## **Attachment 2 to Item 10.3.1.**

Inspection letter dated 24 September 2024 from FRNSW

**Re: INSPECTION REPORT  
PARAGON FILLING (MMP INDUSTRIAL)  
3 HANNABUS PLACE MULGRAVE, also 4 HANNABUS PLACE, 5  
HANNABUS PLACE, 12 HUDSON PLACE, 14 HUDSON PLACE AND 11  
ASPINALL PLACE (“the premises”).**

Appendix 1 – Site Identifiers

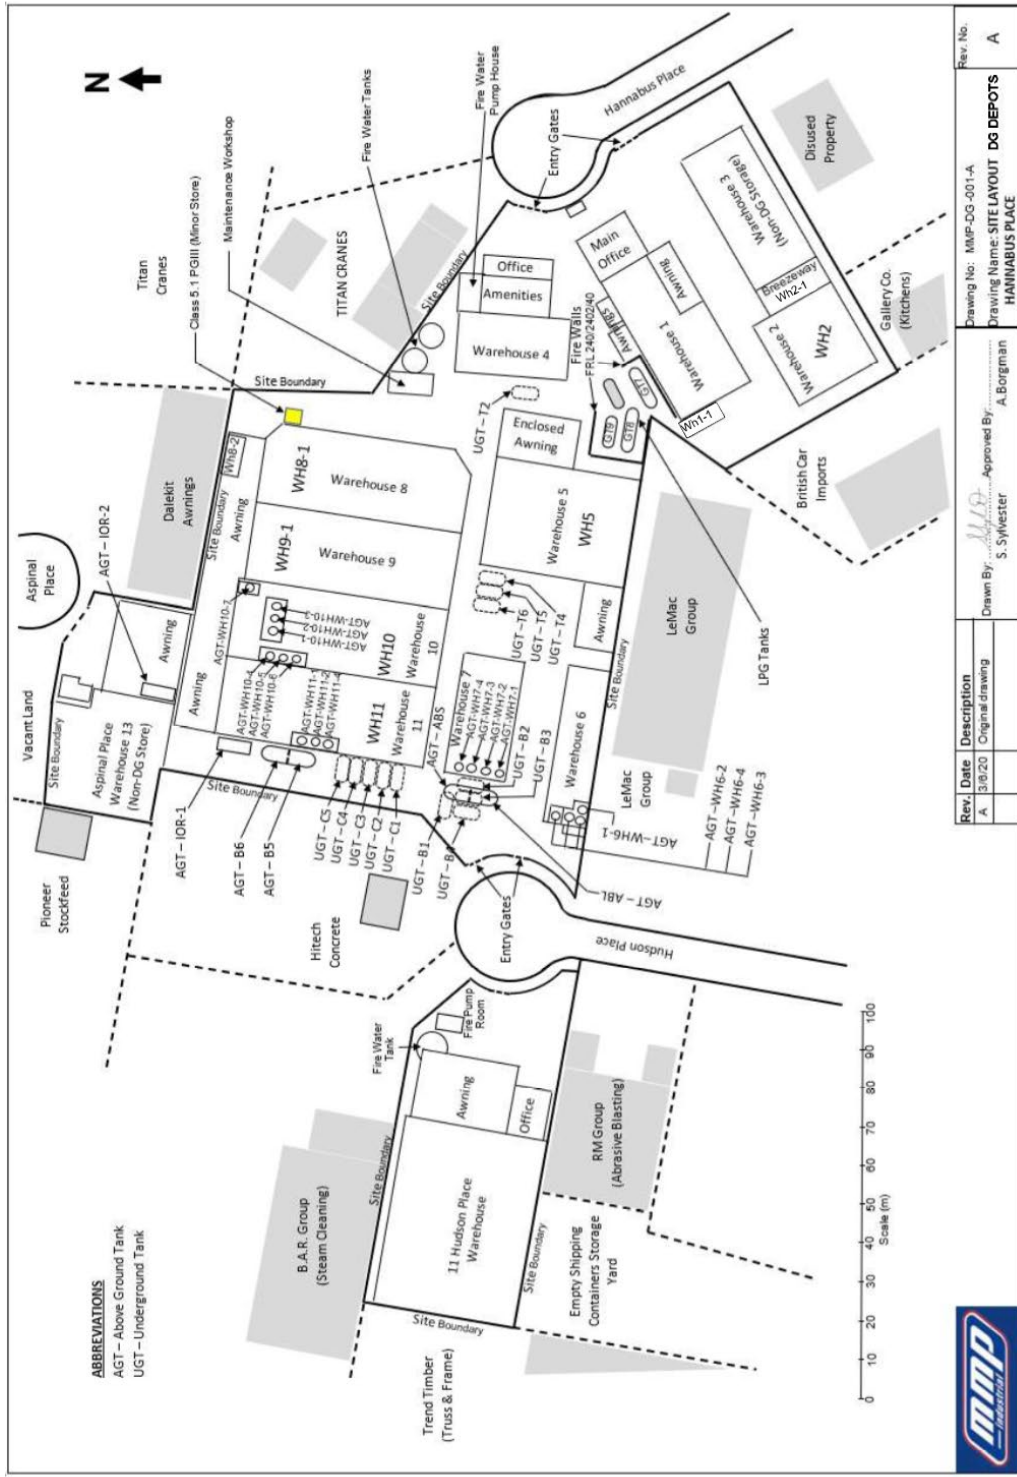
Where used, the building identifiers are referenced at Appendix 1.
